# Recall Bulletin

**SUBJECT: BRAKE PEDAL PUSHROD RETAINER**

**MODELS: 2005 BUICK ALLURE, LACROSSE**

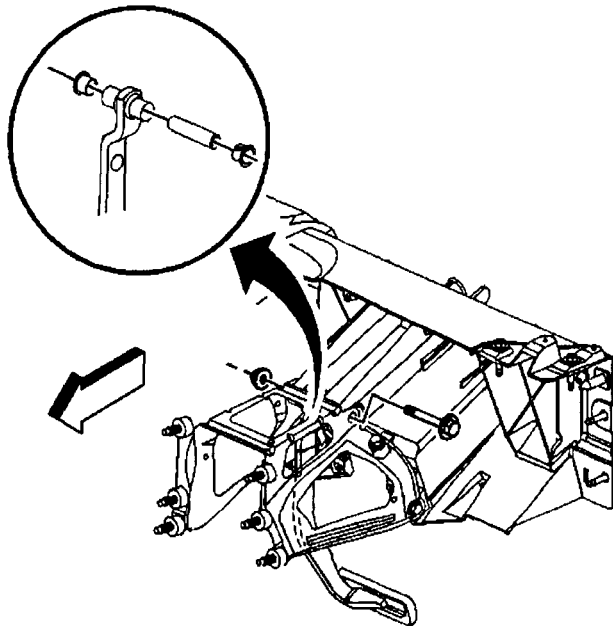
1. Unplug and remove the brake pedal position sensor.
2. Remove the brake pedal pushrod retaining clip from the brake pedal.
3. Remove the brake pedal pushrod and bushing from the brake pedal.
4. Coat the new bushing with white lithium grease (P/N 12345996) before installation.
5. Install a new bushing into the brake pedal pushrod from the outboard side.

**Important: This is opposite the way that the original bushing was installed. The retaining flange should be on the retaining clip side of the brake pedal pushrod.**

6. Install the brake pedal pushrod and bushing to the brake pedal.
7. Install a new brake pedal pushrod retaining clip to the brake pedal.
8. Install a new brake pedal position sensor.

Tighten the screw to 2.0 N·m (18 lb in).
